Electronic Fence

Fence Opening Delays

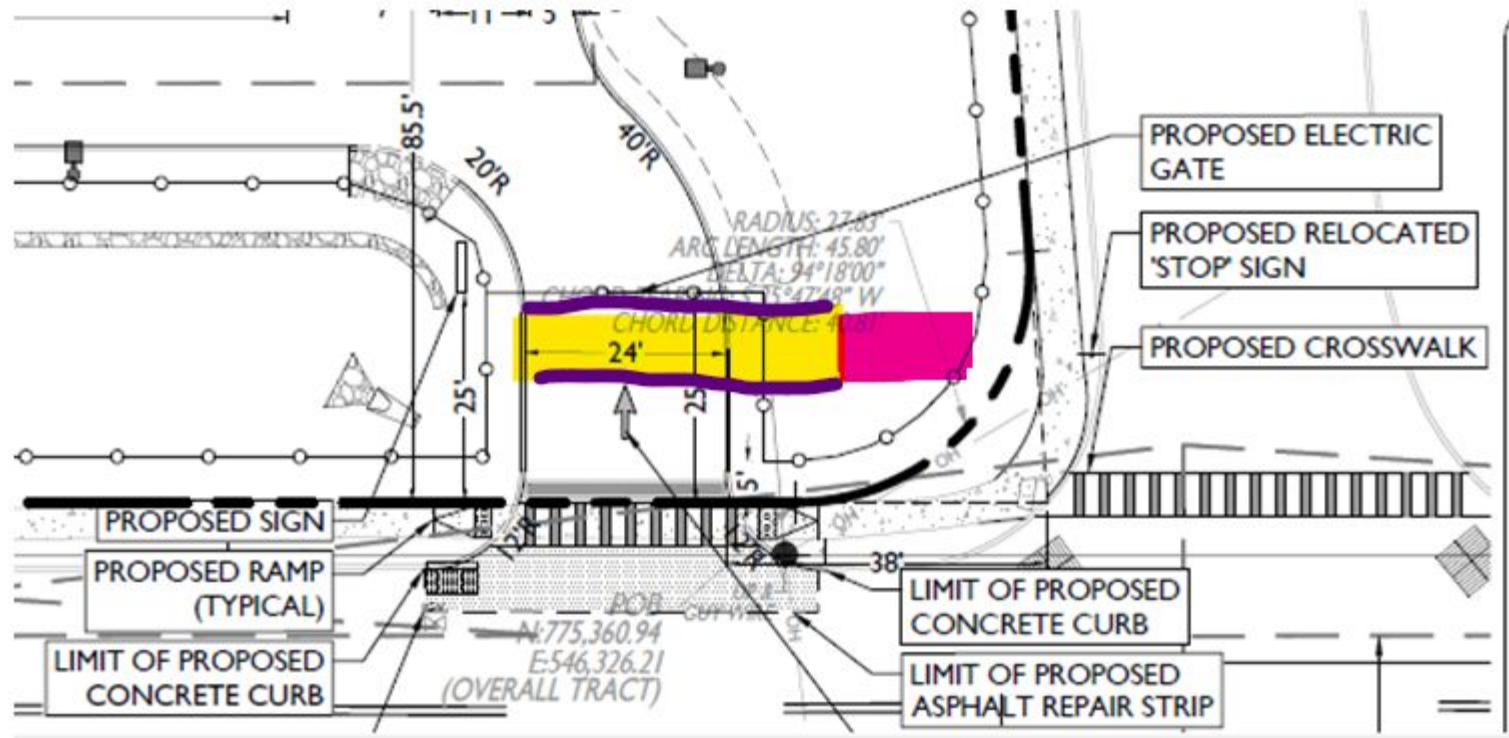
- 24' Fence = ~ 700 lbs
- Time to open = 30 seconds
- Vans arriving at same time = back-up on Roome, Sunset and Washburn

Gate Spec Size is Too Small

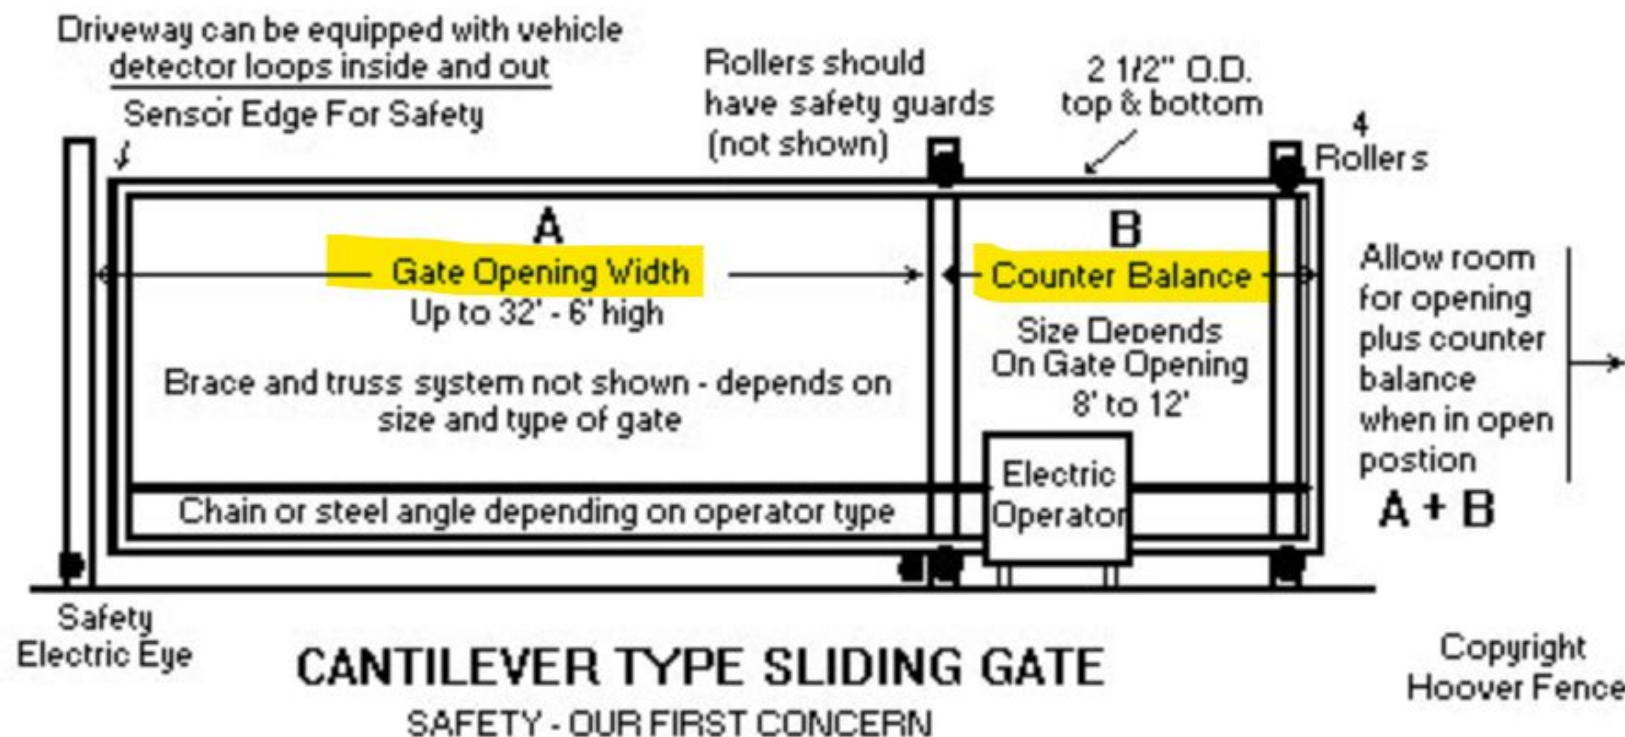
- **24' wide gate** opening requires **allowance of 36'**
- Counterbalance + **12'**

Elevation Change

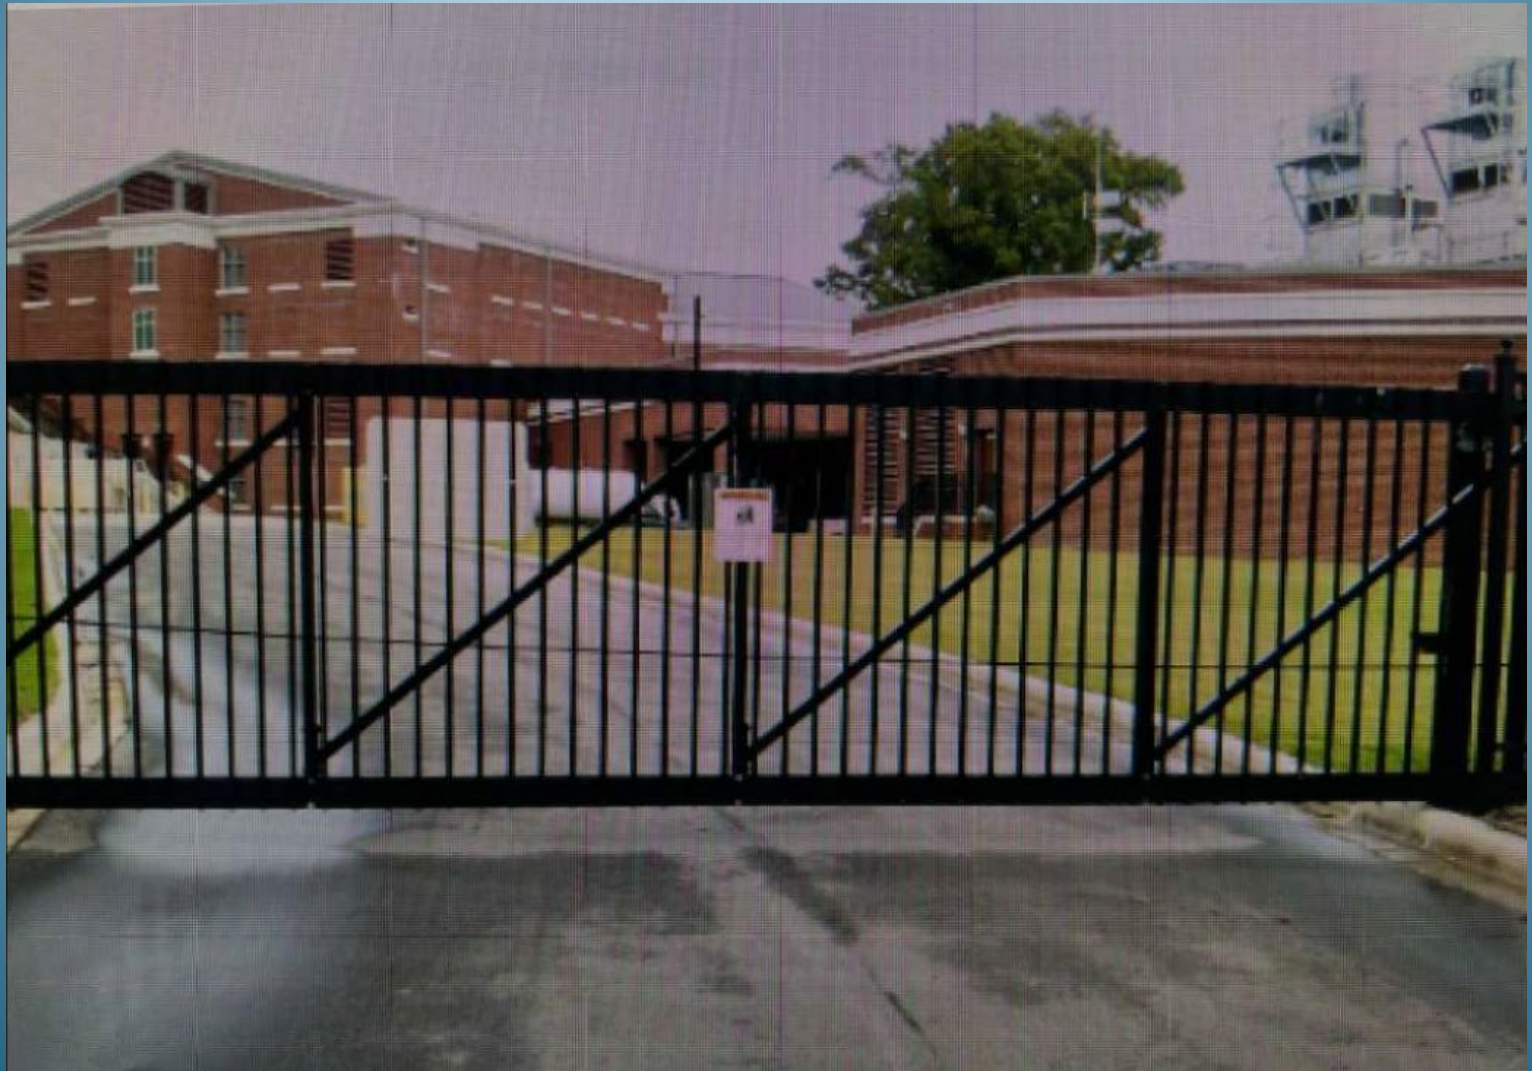
- 2' drop in elevation entranceway to Roome
- To remain level, fence must be ~2 feet off ground
- Resulting height = 7 to 7.5 feet
